# **Marsh Resources, Inc Potomac River Mitigation Bank**

## **Addendum to Bender Farm Mitigation Site Plan**

Permit No. 03-N0183

October 2012

# Revised Credit Plan BENDER FARM MITIGATION SITE

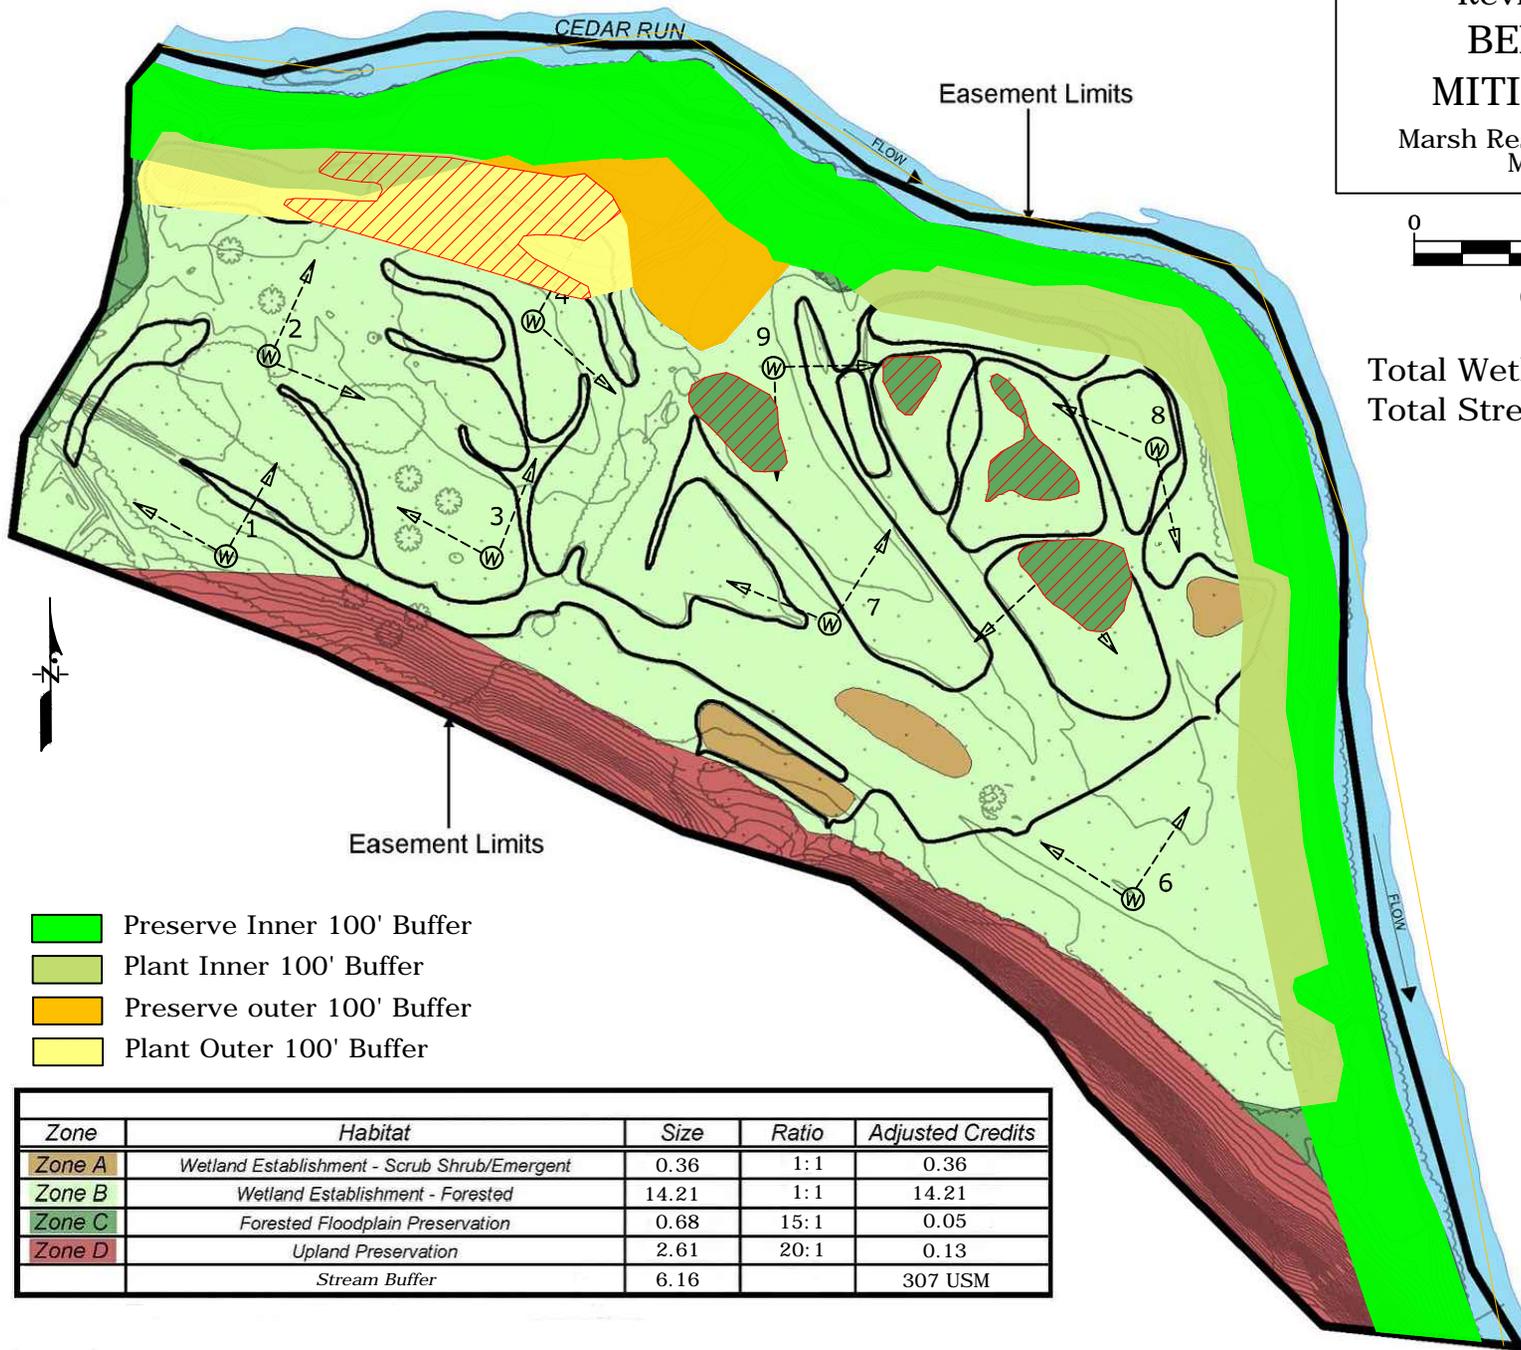
Exhibit 2 – Proposed Revision to Credit Plan

The Sponsor proposes to establish 307 stream credits on the Bender Farm mitigation site as shown in Exhibit 2. USM Form 1 and Form 3 are provided in Exhibit 3 to support the number of proposed credits

The IRT previously released 16.12 wetland credits at Bender Farm. Establishing 307 stream credits on the site would reduce the total number of available wetland credits to 14.75 credits. This credit adjustment also includes 1.1 acres of the site where wetland credits were not released due to insufficient wetland hydrology. We propose to change this 1.1 acre from wetland establishment (1:1) to forested floodplain preservation (15:1). Proposed adjustments to the credit plan are summarized below and shown on Exhibit 2.

Total Wetland Credits = 14.75

Total Stream Credits = 307

Zone	Habitat	Size	Ratio	Adjusted Credits
Zone A	Wetland Establishment - Scrub Shrub/Emergent	0.36	1:1	0.36
Zone B	Wetland Establishment - Forested	14.21	1:1	14.21
Zone C	Forested Floodplain Preservation	0.68	15:1	0.05
Zone D	Upland Preservation	2.61	20:1	0.13
	Stream Buffer	6.16		307 USM

Wetland Credit Not Released = 1.1 acre
